Staff Report

To: Salt Lake City Planning Commission
From: Chris Lee, 801-535-7706
Date: November 8, 2018
Re: PLNSUB2018-00496 and PLNSUB2018-00668 – Guadalupe Row Houses

Planned Development and Preliminary Subdivision

2 FIRE DEPARTMENT ACCESS
1" = 20'-0"

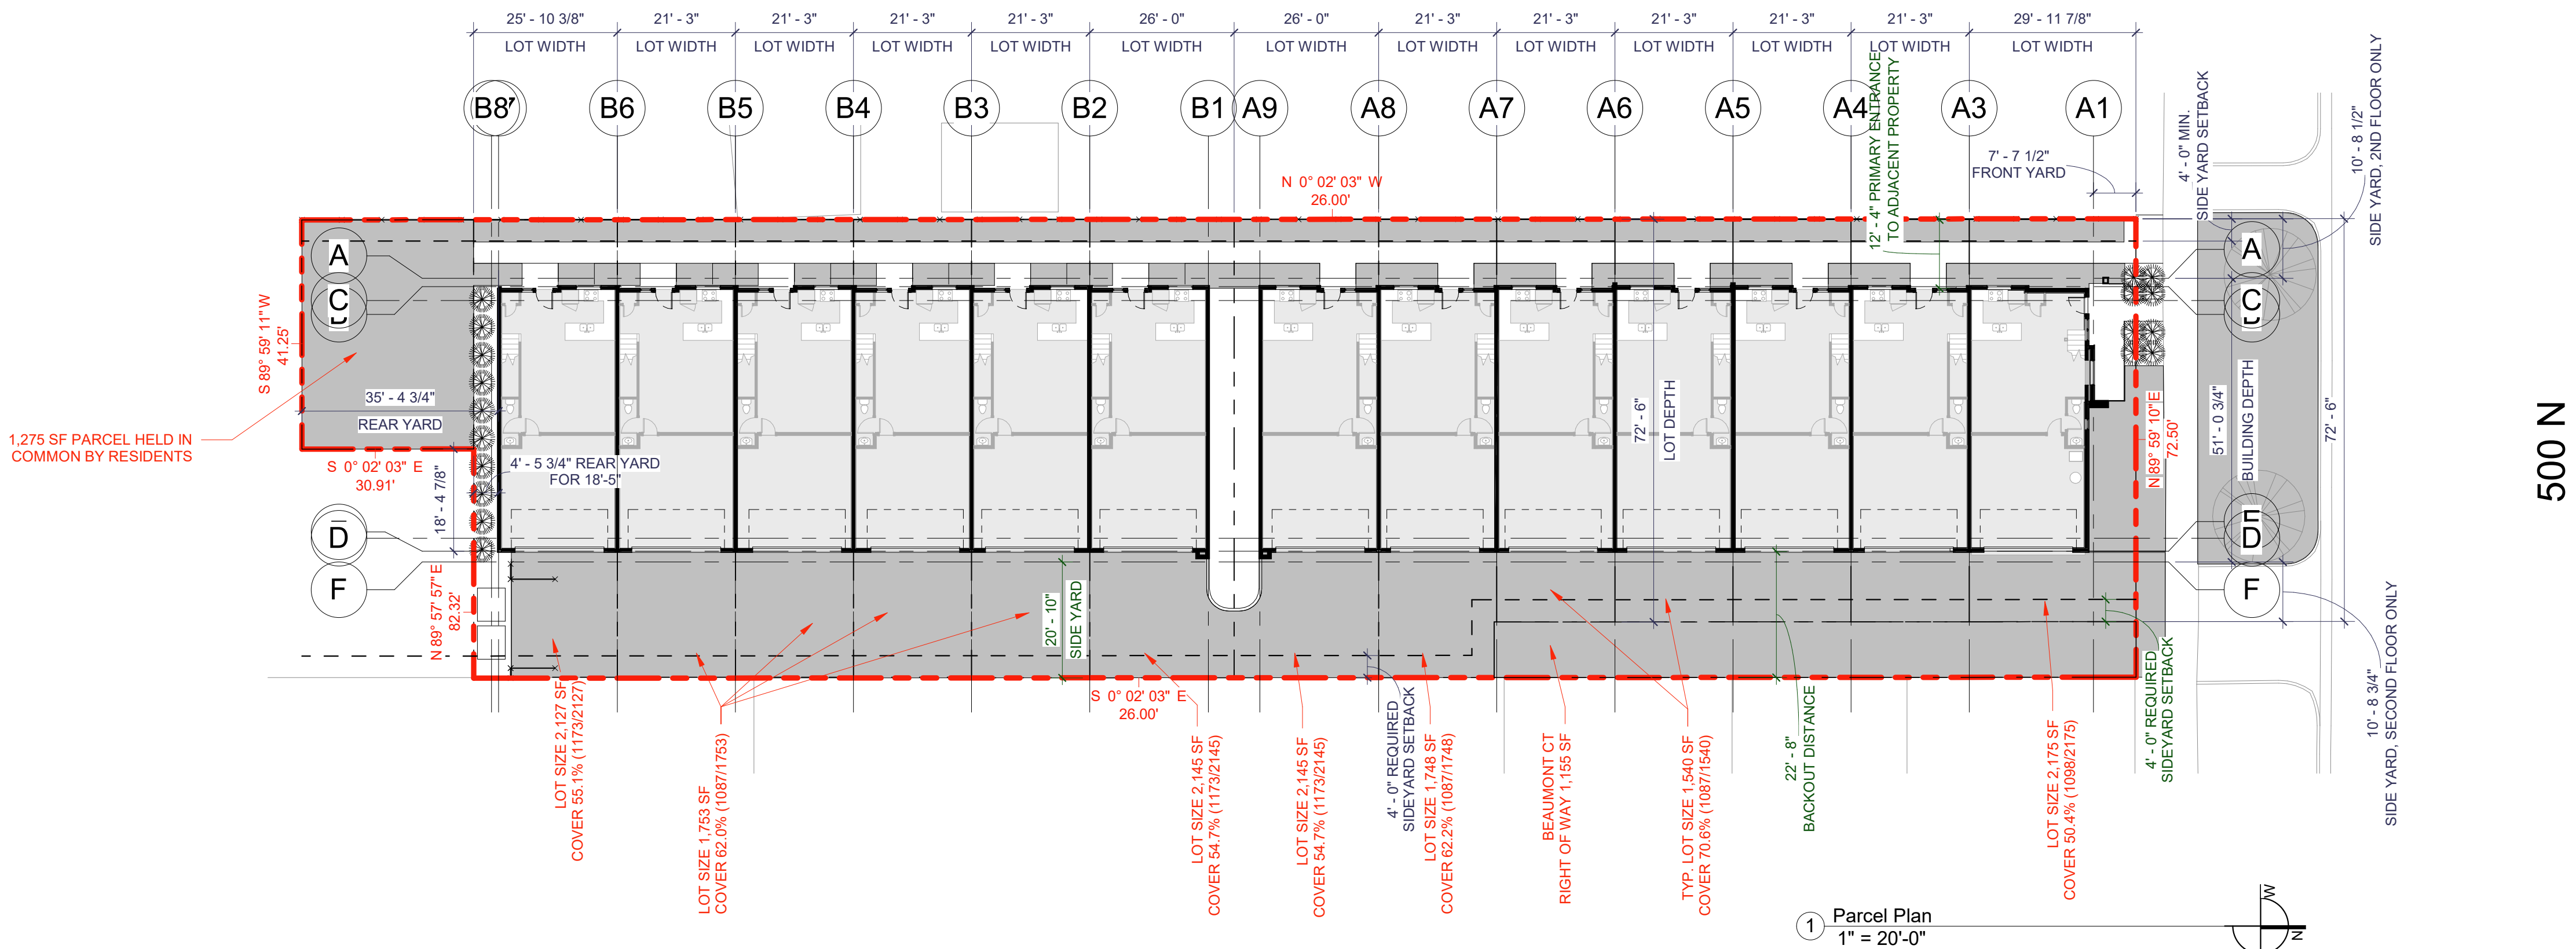
If the structure height is below 30 ft., then a 20 foot clear width and 13 ft. 6 inch clear height will be OK. However it appears that the fire department access road is longer than 150 ft in length. Also the requirement of fire department access is also needs to be within 150 feet of all exterior walls of the first floor. If they could provide a turnaround then the dead-end would not be a problem and they could apply for an Alternative Means and Methods to provide different fire protection. I have reprinted the sections of the International Fire Code regarding providing additional fire protection and a description of a modified hammerhead.

We are proposing using a 13D automatic sprinkler system on both buildings as a means of providing life safety protection in lieu of having the fire access road within 150' of the structure.

1 Parcel Plan
1" = 20'-0"

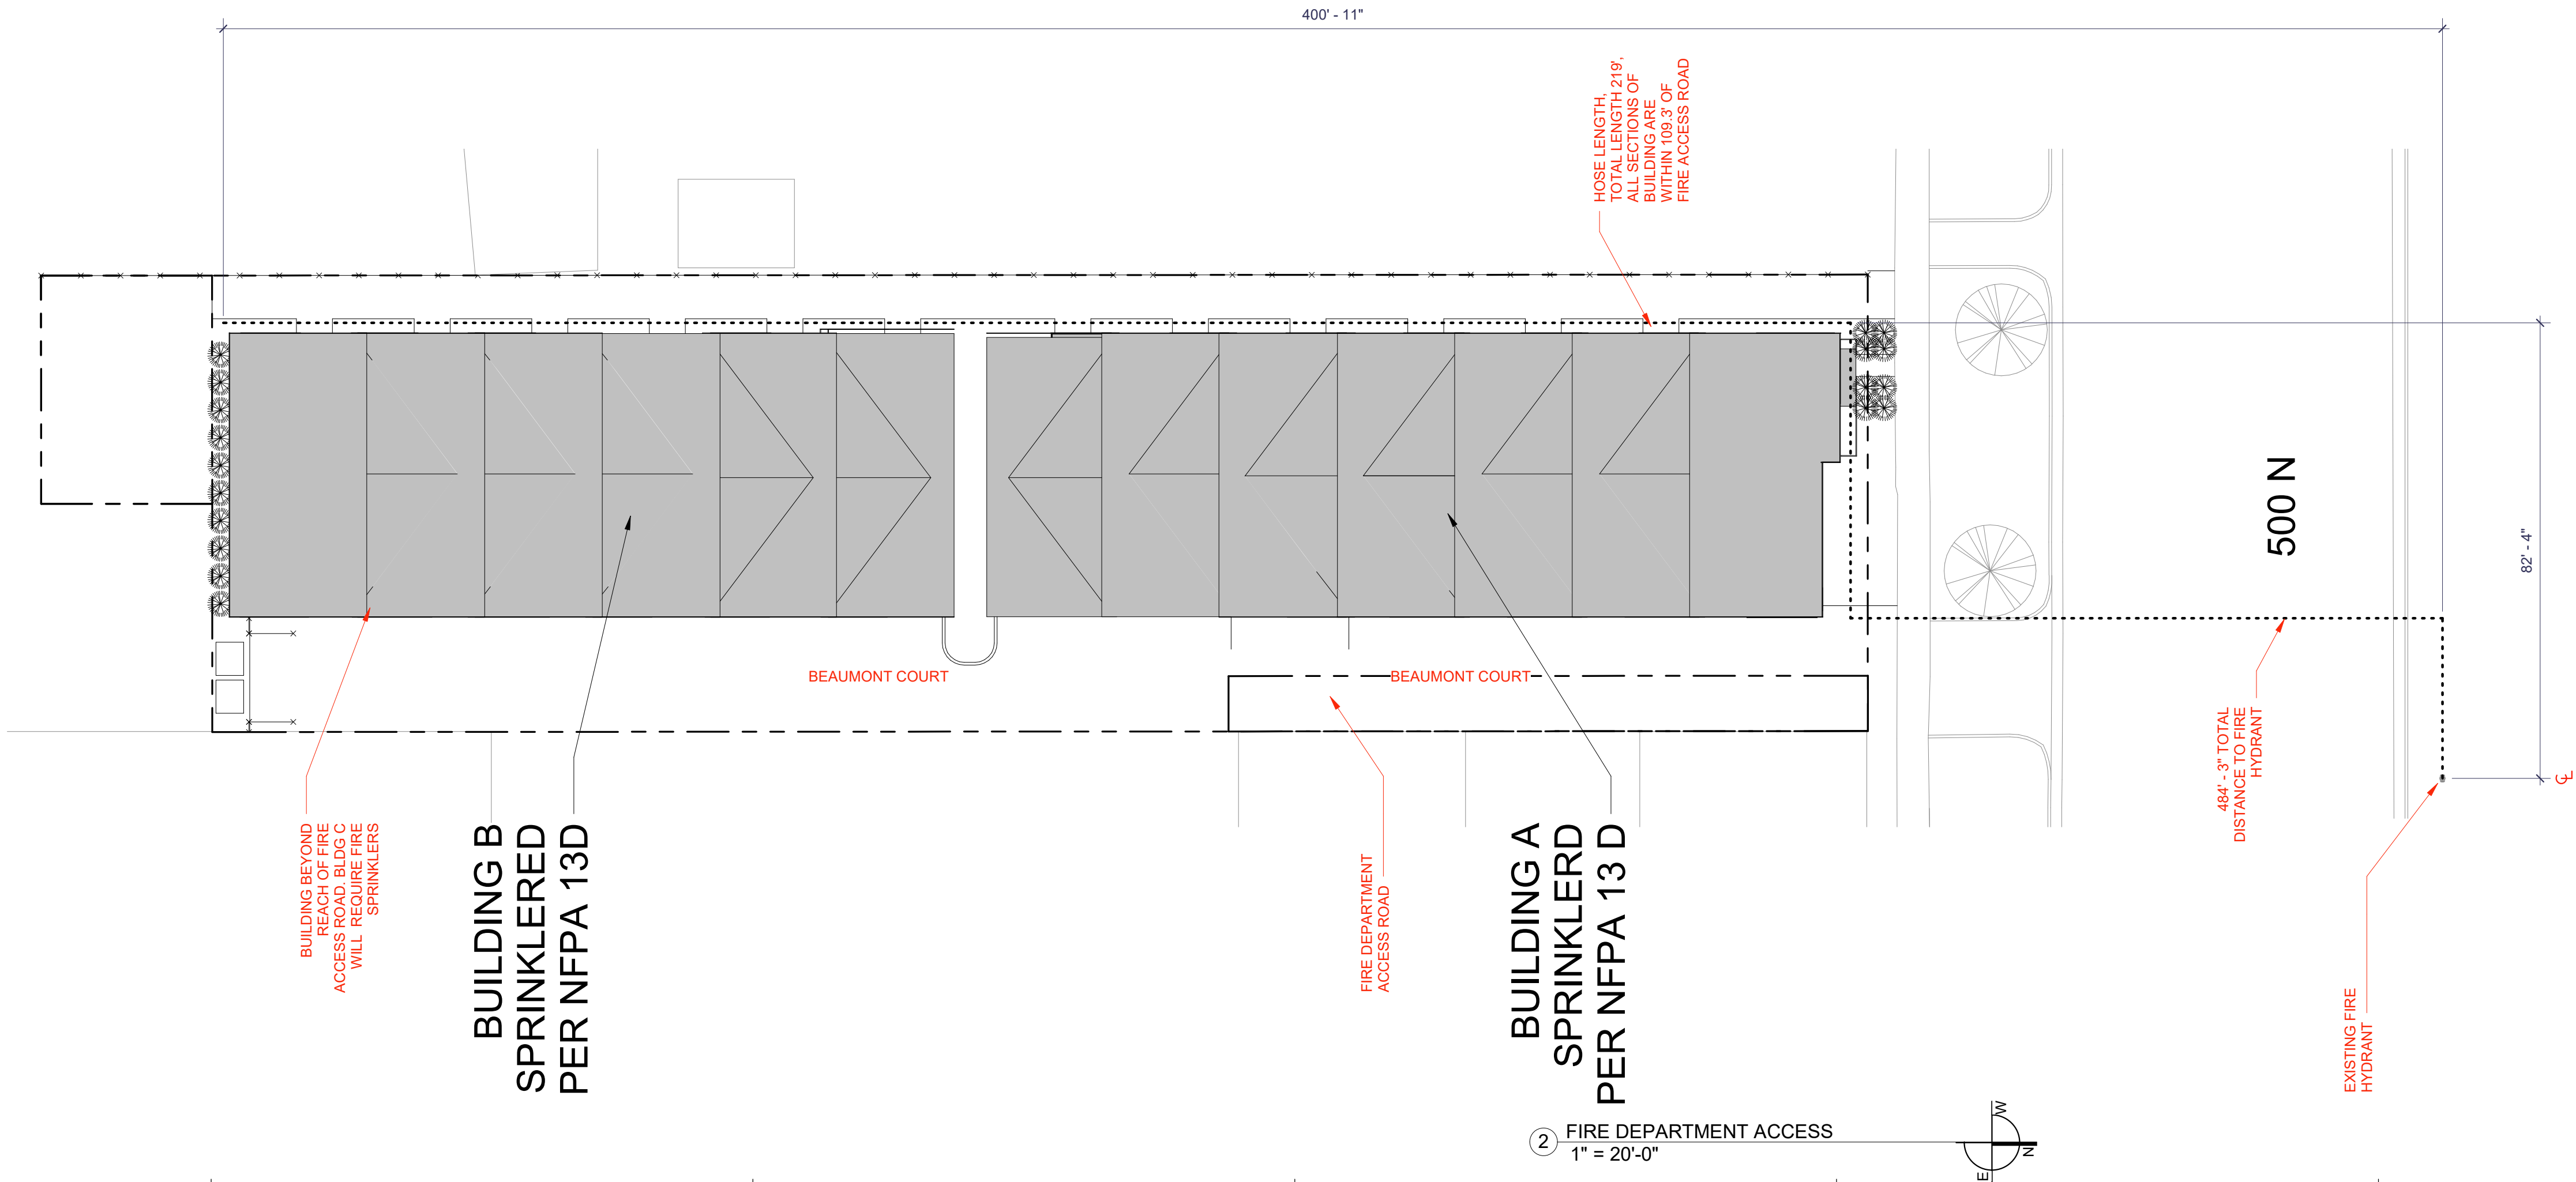
As shown on the map, the average of the front yard setbacks along the block face is 9' 6", establishing it as the required setback for the proposed structures. The applicant is petitioning to reduce down to 7' 7.5" seeing as the proposal does not meet the setback requirement. Planning Staff believes the request to be reasonable in that it is a relatively minor adjustment and serves to transition between the SR-1A and TSA-UC-T zones. Similar to the SR-3 zone, the SR-1A zone considers the average setbacks of existing buildings along the block face to set the standard. However, it has a minimum of a 20 foot setback otherwise, while the SR-3 setback is 10 feet and the TSA requires no setback at all. Consequently, the requested reduction serves to transition between greater setbacks to the west and no setbacks to the east.

AVERAGE FRONT YARD CALCULATION
 $0' + 12.7' + 0' + 9.9' + 12.7' + 13.1' + 11.0' + 16.6' = 76.0'$
 $76.0' / 8 \text{ PARCELS} = 9.5'$
AVERAGE BLOCK FRONT YARD

SITE PLAN

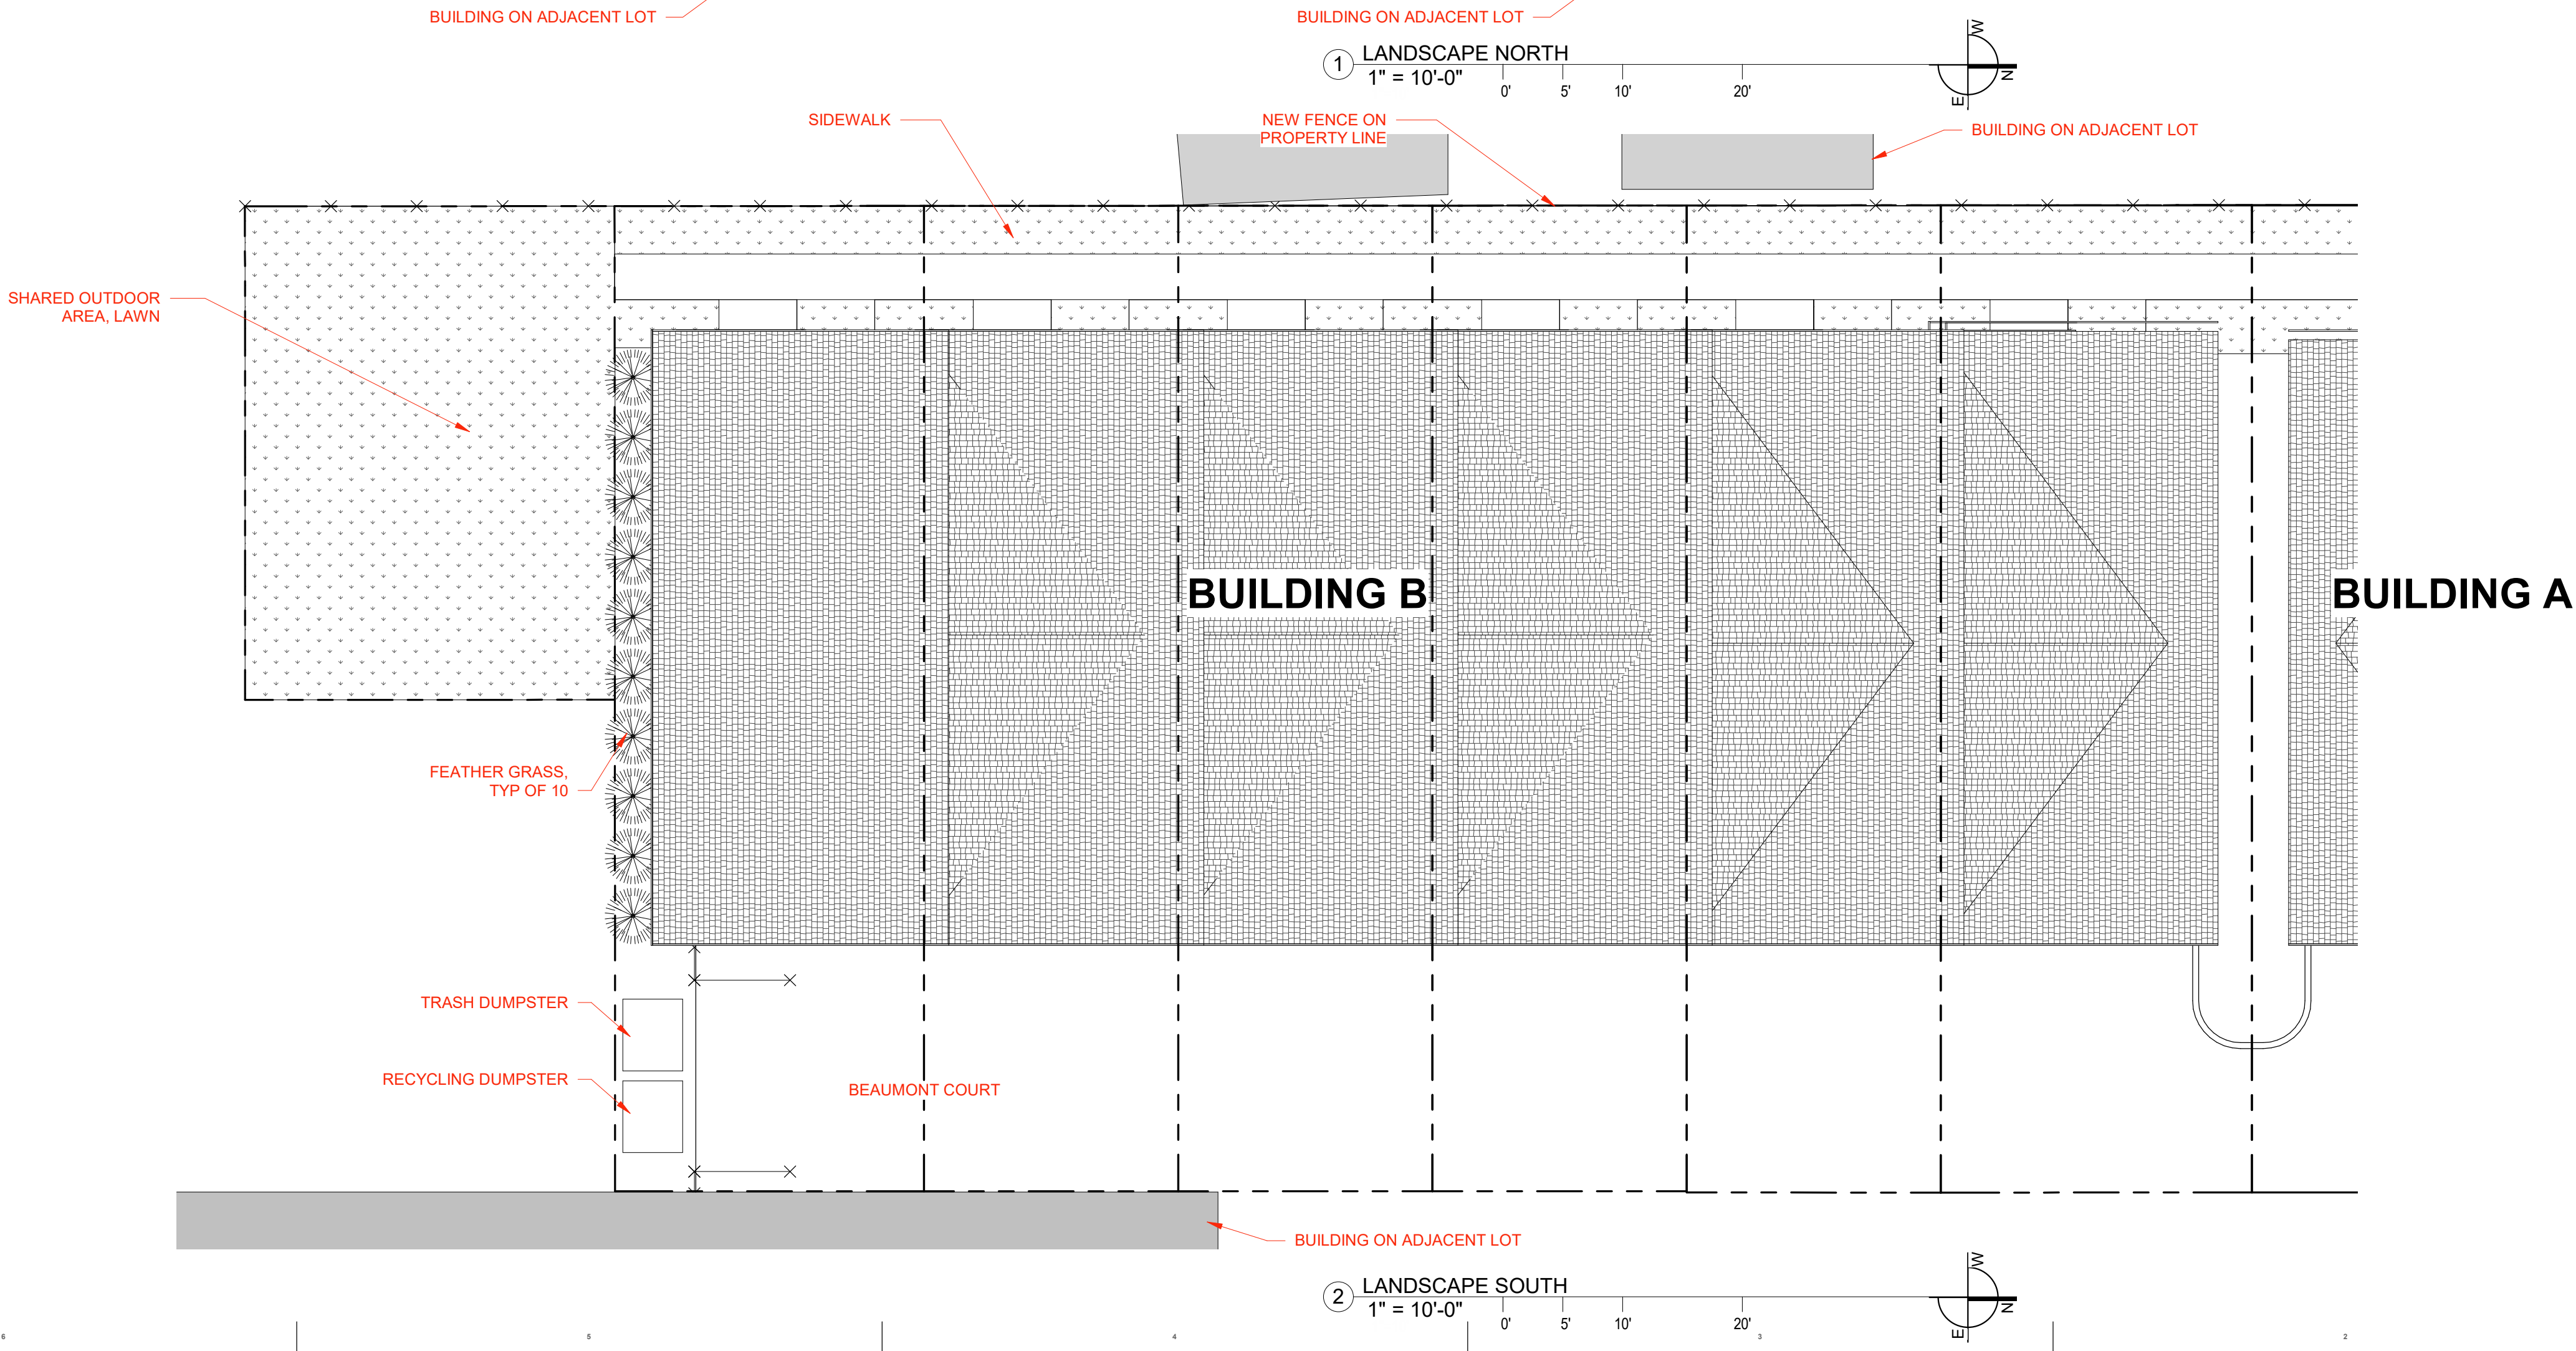
The Feathered Reed Grass shown on the Landscape Plan is not an acceptable choice for planting in the ten foot (10') sight distance triangle at the driveway since it can grow to a height of four feet (4').

3	<p>21A.24.010 N. Front And Corner Side Yard Landscaping: All required front and corner yards should be maintained as landscape yards. In addition, all uses in residential districts shall comply with the provisions governing landscaping in chapter 21A.48 of this title.</p> <p>The Feathered Reed Grass shown on the Landscape Plan is not an acceptable choice for planting in the ten foot (10') sight distance triangle at the driveway since it can grow to a height of four feet (4').</p> <p>Feathered Reed Grass has been removed from this location and replaced with turf grass.</p>	
4	<p>Any park strip tree removal/protection/planting will need to be evaluated by Urban Forestry. The Demo Site Plan does not indicate the location of existing park strip trees and whether they are to be removed or retained.</p> <p>Demo plan and landscape plan have been adjusted to show the two existing street trees to remain.</p>
